**KINGDOM OF BELGIUM**

**FEDERAL PUBLIC SERVICE ECONOMY,  
SMEs, SMALL BUSINESSES AND  
ENERGY**

**Royal Decree amending certain parts of Chapter 7.1 of Book 3, introduced by the Royal Decree of 8 September 2019 establishing Book 1 on low-voltage and extra-low-voltage electrical installations, Book 2 on high-voltage electrical installations and Book 3 on installations for the transmission and distribution of electrical energy**

Table 7.10. Types of safety devices

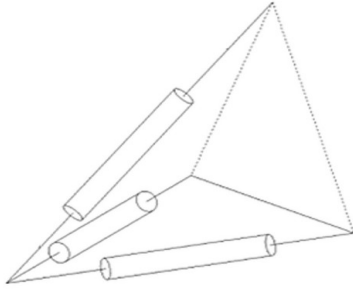
**Art. 31.** In Annex 3, Book 3, Part 7, Chapter 7.1, Section 7.1.6, Subsection 7.1.6.4, Point b.2, of the same decree, Table 7.11 is replaced by the following:

Type: safety device	Illustration	Requirement
<p>a. with rigid insulators</p>	<p>Figure 7.2. Rigid insulators - Top view</p>  <p>Figure 7.3. Rigid insulators - Perspective</p> 	<p>Each conductor in a line equipped with rigid insulators is attached to the support by means of at least two insulators, sufficiently spaced apart to prevent a grounding arc occurring at one insulator from propagating to another.</p> <p>The line conductor is attached to one of the insulators and connected to each of the additional insulators by a conductor of the same cross-section and of the same type to which it is connected on both sides of the attachment point.</p> <p>The attachment of these conductors to their insulators and the connection of the conductors to each other are achieved using special fasteners capable of preventing any slippage without compromising the mechanical strength of the conductors.</p>
<p>b. With suspension type insulators with double insulator chains</p>	<p>Figure 7.4. Semi-anchor type - Elevation view</p>  <p>Figure 7.5. Anchor type - Elevation view</p>  <p>(1) Insulators</p>	<p>Each conductor of a line equipped with suspension type insulators is held by means of attachment pieces at the ends of at least two chains of insulators. The conductor is attached to each chain by means of an anchor or a suspension type clamp providing a semi-anchor. A splitting strap consisting of a conductor is attached by means of fasteners on either side of the terminal pieces of the insulator chains.</p> <p>This splitting strap can be connected to the conductor by one or more additional fasteners located between the attachment points to the insulator chains.</p> <p>The splitting strap, on the one hand, and the connection between the conductors of the anchor type safety device, on the other hand, are made up of a conductor of the same cross-section and of the same nature as that which is used for the line, or equivalent.</p>

<p>c. with suspension type insulators with a single chain of insulators</p>	<p>Figure 7.6. Single chain of insulators - Elevation view</p>  <p>(1) Insulators</p>	<p>Each conductor on a line equipped with suspension type insulators is held by a single chain of insulators. The conductor is split by a splitting strap consisting of a conductor of the same cross-section and of the same type as that which is used for the line and attached on either side of the fastening point of the latter to the chain of insulators.</p>
<p>d. Insulating pylon brackets</p>	<p>Figure 7.7.a Example of a bracket with insulating arm with an insulator - Perspective</p> 	<p>The brackets with insulating arms are primarily composed of at least one insulator (or an insulator chain) and metal parts that connect the conductors via the construction elements with the support. They are used as enhanced safety devices. Brackets with insulating arms compensate for the mechanical forces of the conductors combined with the forces caused by wind or</p>
